Joplin Public Library

Joplin Public Library Furniture Bid Package
OPN Project #: 14289000
EDA #: 05-79-05345

Addendum #1
November 16, 2016

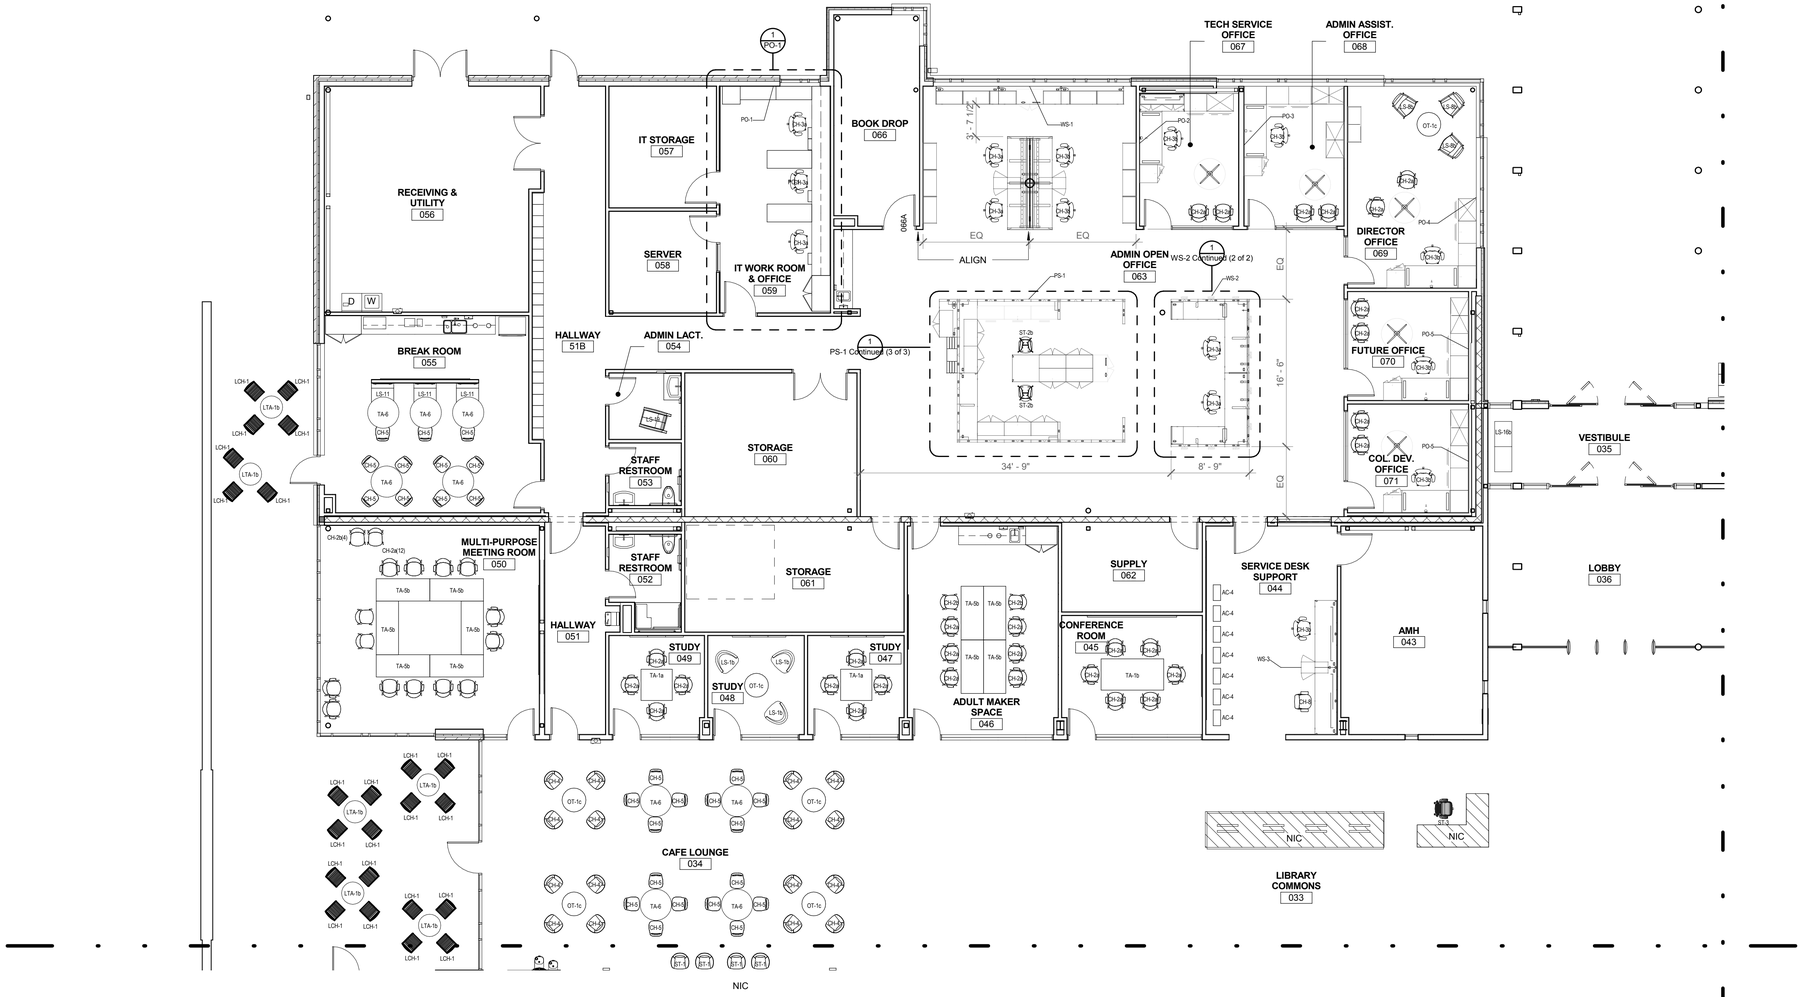
1. AC-7 – Model # to be revised to: AVCL-2845-V-SS-FSU-FSL-SH. "Wood Finish" description shall be revised to match the following:

a. Lectern Finish: Veneer Stained to Match Designer Sample

b. Shelf Paint Finish: S8004 Cloud

c. Metal Finish: A8006 Foil

Type Mark	Count	Item	Manufacturer	Model	Model #
AC-7	1	Lectern	Nucraft	High Tech Lectern	AVCL-2845-V-SS-FSU-FSL-SH

Wood Finish	Special Instructions
Lectern Finish: Veneer Stained to Match Designer Sample Shelf Paint Finish: S8004 Cloud Metal Finish: A8006 Foil	Lower shelf to have 2" grommet and cable shroud. Microphone shall be provided by owner.

CB-1a
ITEM CODE

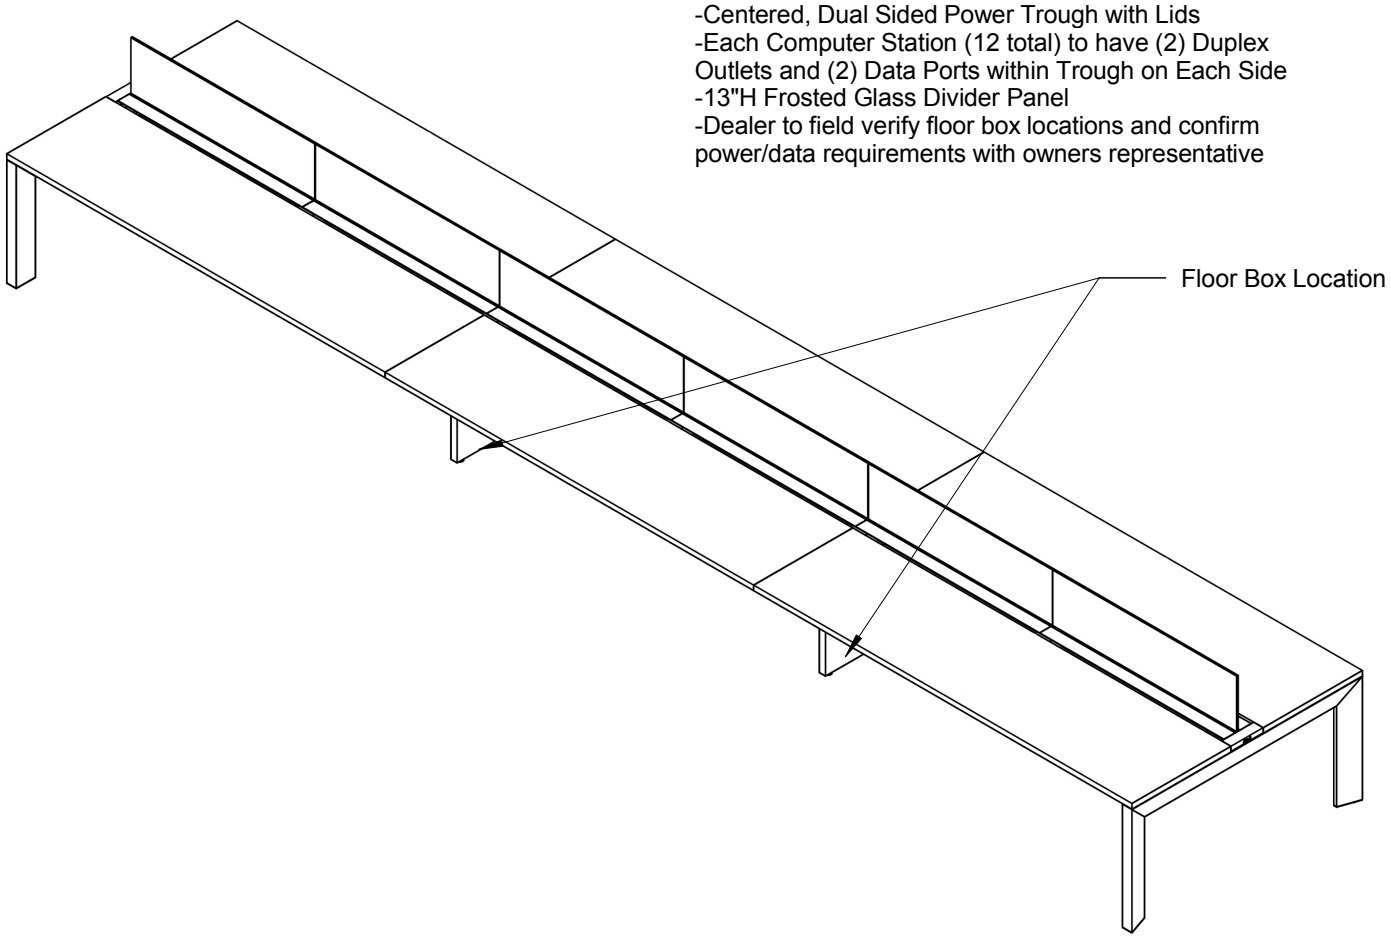
1. Images for CB-1a and CB-1b were not included in the original package. Please replace the specification sheets with the attached documents.

Dual Sided Benching, Beam Support
-252"L 60"D
-(6) 84"W 24"D Worksurfaces
-Centered, Dual Sided Power Trough with Lids
-Each Computer Station (12 total) to have (2) Duplex Outlets and (2) Data Ports within Trough on Each Side
-13"H Frosted Glass Divider Panel
-Dealer to field verify floor box locations and confirm power/data requirements with owners representative
